ADDENDUM NO. 1

Lincoln Public Schools
Seacrest Field – Maintenance Parking Lot Expansion – Phase III
Lincoln, Nebraska - 2013
OA Project No. 011-2227

STORM SEWER IMPROVEMENTS PLAN AND PROFILE SHEET

RIP-RAP DETAIL
NOT TO SCALE

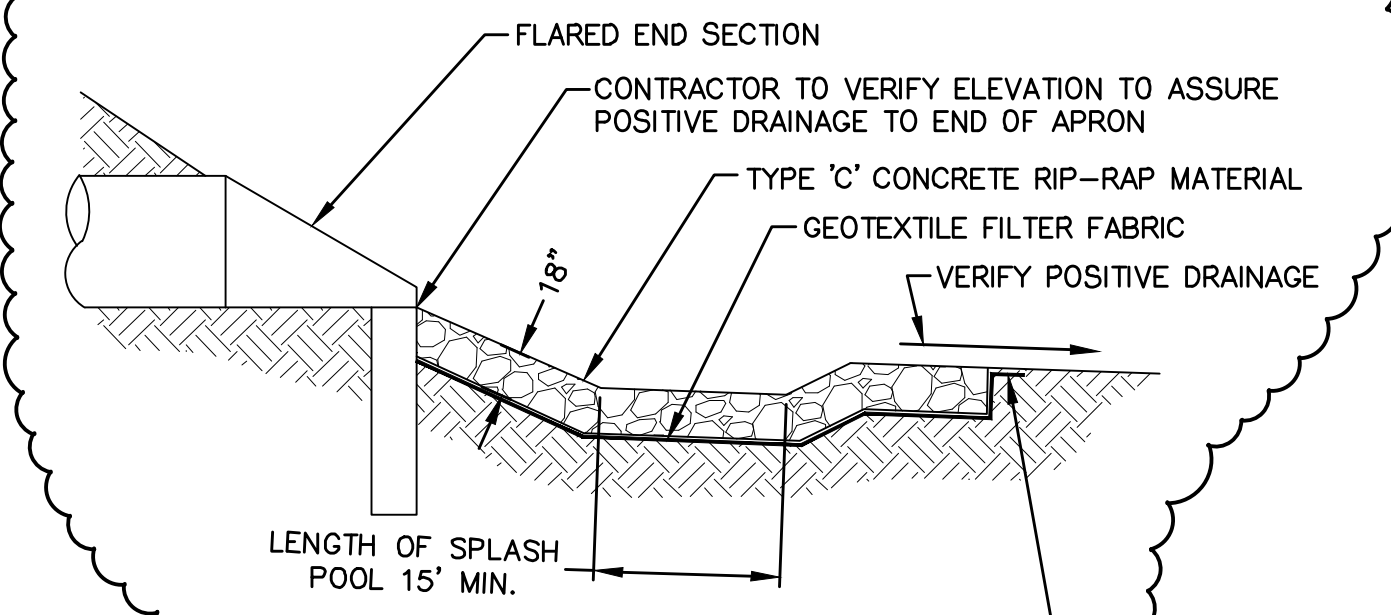
1. Revise the type and quantity of Rip-Rap Material.
 - A. See attached plan sheet 1 of 1.

- N:200806.69, E:183471.19
STA: 0+17.75 (54" STORM SEWER)
TAP PROPOSED 54" STORM SEWER
W/ 12" STORM SEWER
FL(54")=1250.72
FL(12")=(CONTRACTOR TO VERIFY)
- N:200882.65, E:183484.86
STA: 0+95.00 (54" STORM SEWER)
PTHC "B"
INSTALL
1-54" FLARED END SECTION, W/ TOEWALL
LINE CHANNEL & SIDE SLOPES WITH 56 TON
OF TYPE 'C' CONCRETE RIP-RAP,
PLACED ON GEOTEXTILE FILTER FABRIC
PER LINCOLN STANDARD PLAN 177
FL(54")=1249.50

REV. NO.	DATE	REVISIONS DESCRIPTION
2	8/26/13	REVISED OUTLET PROTECTION
